SYDNEY WEST CENTRAL PLANNING PANEL

COUNCIL ASSESSMENT REPORT

Panel Reference	2017SWC011
DA Number	DA/585/2016/A
LGA	City of Parramatta
Proposed Development	Section 96(2) modification to approved 17 storey mixed-use development including, but not limited to, increase in height of Tower A by 420mm, larger balconies at Level 8, reduction in floor area, modified unit mix, addition of essential services, inclusion of basement ventilation stacks and changes to the facade design.
Street Address	30 – 42 Oxford Street, Epping (Lot A DP 354692, Lots 1A and 1B DP 102387 and Lot C DP 389716)
Applicant	Cardno Pty Ltd
Owner	Greaton Epping Holdings Pty Ltd
Date of DA lodgement	22 December 2016
Number of Submissions	Seven (7)
Recommendation	Approval subject to revised conditions
Regional Development Criteria (Schedule 4A of the EP&A Act)	Pursuant to Clause 21 of State Environmental Planning Policy (State and Regional Development) 2011, the proposal is a s96(2) modification to an application with a capital investment value of more than \$20 million.

Report prepared by	Alex McDougall Executive Planner, City Significant Development
Report date	18 October 2017

Figure 2. Section from original proposal showing step down into retail unit.

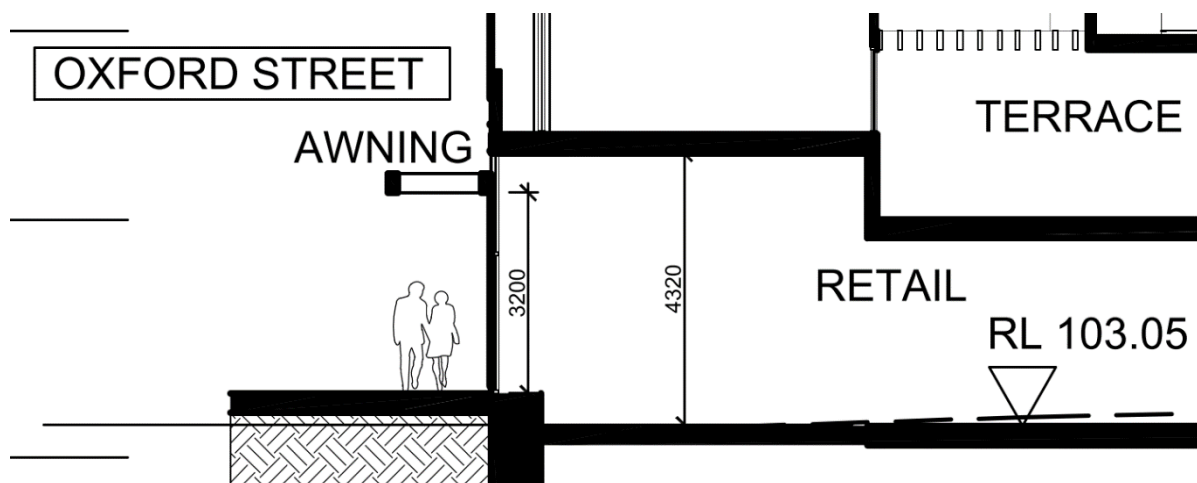
The proposed modifications would result in an increase in the height of Block A by 420mm from an originally approved height of 52.8m to 53.22m (0.8% increase).

The ground floor retail was originally approved a step down from street level. The height increase is proposed to allow a step-free transition from the public domain to the retail unit.

- The increase in height is numerically negligible and the associated impact on overshadowing will also be negligible and thus acceptable.
- A level retail level will improve the accessibility of the retail units for less able bodied persons.
- A level retail level will reduce the likelihood of overland flow waters entering the retail level and damaging property.

Figure 3. Ground Floor Plan with zoning map overlay and approximate 20m zone interface zone (blue: B2 zone, red: R4 zone, yellow: approximate 20m zone interface).

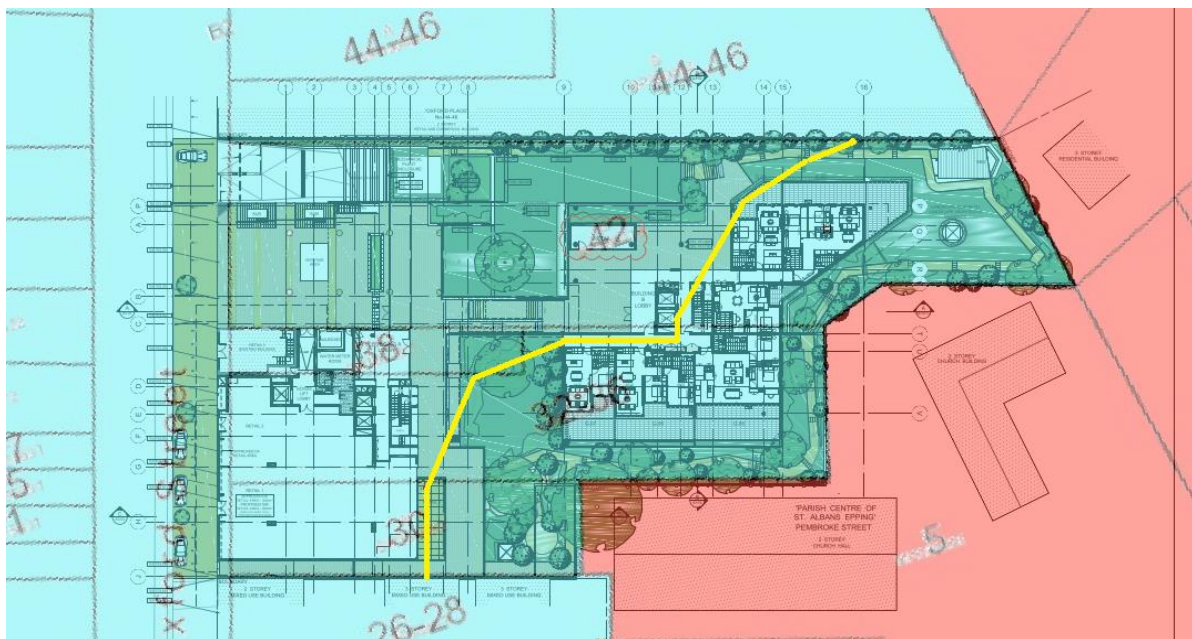
The proposed modification includes transferring approximately 61sqm of commercial floor space from the ground floor of Tower B to the ground floor of Tower A. The Tower B ground floor retail unit would be reduced from 88sqm to 27sqm.

- The proposal would not result in a net decrease in the total amount of commercial floor space approved on site. As such the proposal is still considered to satisfy the B2 zone objective of providing a range of retail, business, entertainment and community uses that serve the needs of people who live in, work in and visit the local area.
- The proposal would minimise the amount of commercial floor space without a street frontage. The Tower B unit is still considered to be large enough to accommodate a small business.
- Maintaining a commercial unit to tower B is necessary to ensure that tower remains a permissible 'shop-top housing' development. The ground floor residential flat building component of Tower B is permissible by way of Clause 5.3 'Development Near Zone Boundaries' as proposed units are located within 20m of land zoned R4 'High Density Residential' (see Figure 3 below).

Figure 4. Originally Approved Front Public Open Space Area (left) vs. Modified (right)

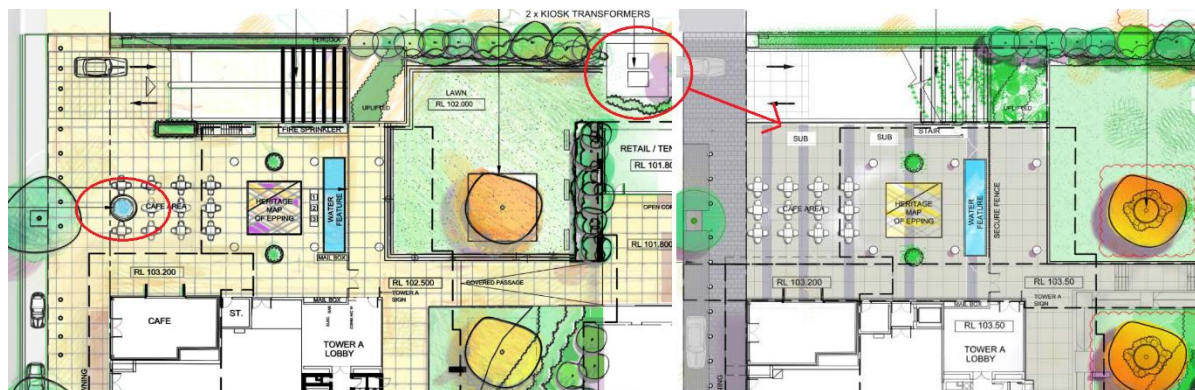
The proposal modification includes relocating the electrical substations from their originally proposed location mid-block to the front public open space area, adjacent to the driveway. The modification also includes removal of a small water feature from the front setback area.

The modifications are necessary to meet the accessibility requirements of the electricity provider.

- The substations must be easily accessible by the energy provider in the event of an emergency; they were not accessible previously. The proposed location, in close proximity to the driveway, is considered to be ideal.
- The substations are not considered to unacceptably compromise the amenity of the public open space.
- It is not possible to widen the open space as it is constrained by the driveway to the north and heritage item to the south.
- The small water feature provided minimal amenity and would impede the ability of utility vehicles to access the transformers.

Figure 7. Approved Level 8 Floor Plan

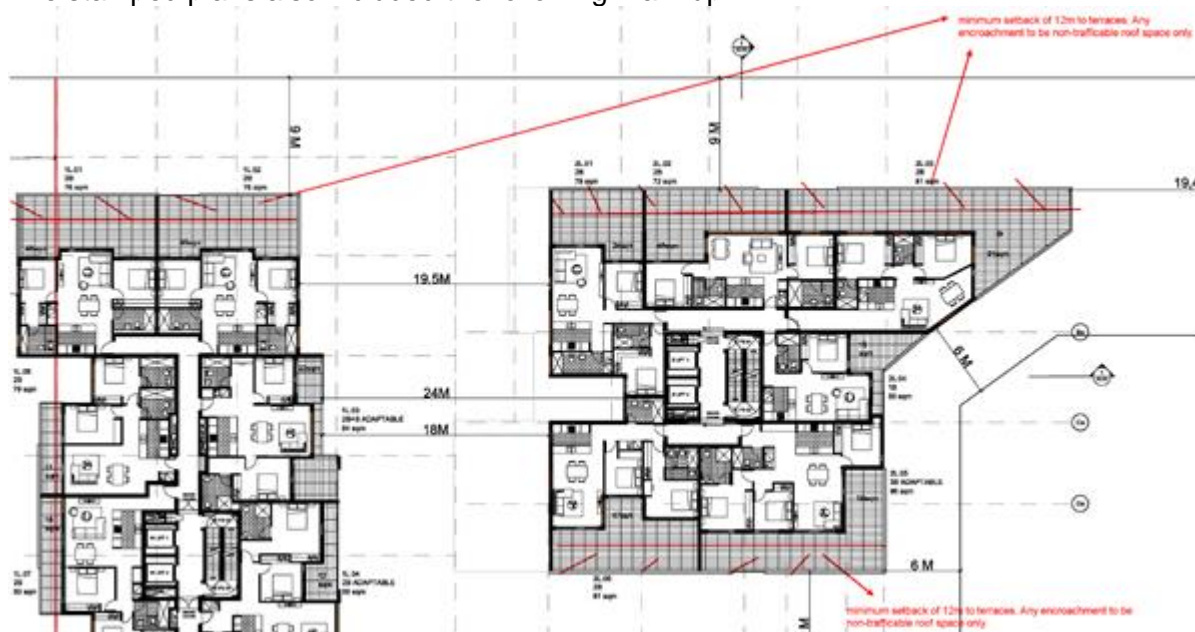
The proposal includes a request to delete condition 5b and 5c which required the following:

- b) *All north-facing terraces on the Level 8 floor plan for Towers A and B in DA 1.09 Issue E dated 3/05/2016 are to have a minimum setback of 12m from the northern boundary. Any encroachment is to be in the form of non-trafficable roof space only.*
- c) *All south-facing terraces on the Level 8 floor plan for Tower B in DA 1.09 Issue E dated 3/05/2016 are to have a minimum setback of 12m from the northern boundary. Any encroachment is to be in the form of non-trafficable roof space only.*

Based on the original assessment report the condition was primarily imposed to protect the privacy of adjoining and nearby properties. The applicant considers this condition is not necessary to achieve this aim.

- The applicant has provided a section (see Figure 8 below) demonstrating that the views from the balconies on level 8 would primarily be on to the roof of adjoining structures.
- The ADG requires a 9m setback for the first 25m height of a building and the proposal satisfies this control.
- The larger balconies would provide additional amenity to the residents of those units.
